MONTGOMERY COUNTY DEPARTMENT OF PARK AND PLANNING

Board of Appeals case no. S-2651, Non-Residential Professional Office,

7025 Mac Arthur Boulevard, Bethesda, 2,802 sq. ft. of gross floor area

RECOMMENDATION

Figure 3: Street and Highway Plan, Bethesda Chevy Chase Master Plan, April 1990, Page 123.

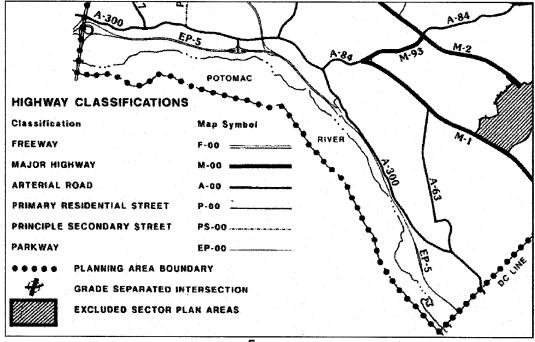
Mac Arthur Boulevard was proposed as a Maryland Scenic "highway" in the Master Plan, and the Master Plan's Street and Highway Plan, pages 123-25, describes the Master Plan's various "street and highway" classifications, including the terms "Freeways", "Major Highways, Arterials", "Primary Residential Streets" and so on. This supports staff's opinion that MacArthur Boulevard, and arterial road, satisfies the highway requirement of Section 59-G-2.83. The following "Street and Highway Plan" map includes "highway classifications" in the Master Plan (Page 123). The map legend in the latter map (Figure 3) suggests that Mac Arthur Boulevard, an arterial road, is a "highway," as an arterial road is a class of highway.

Given the Zoning Ordinance definition of "road" within the context of the Master Plan, staff concludes that *MacArthur Boulevard is a highway, classified as an arterial road.*
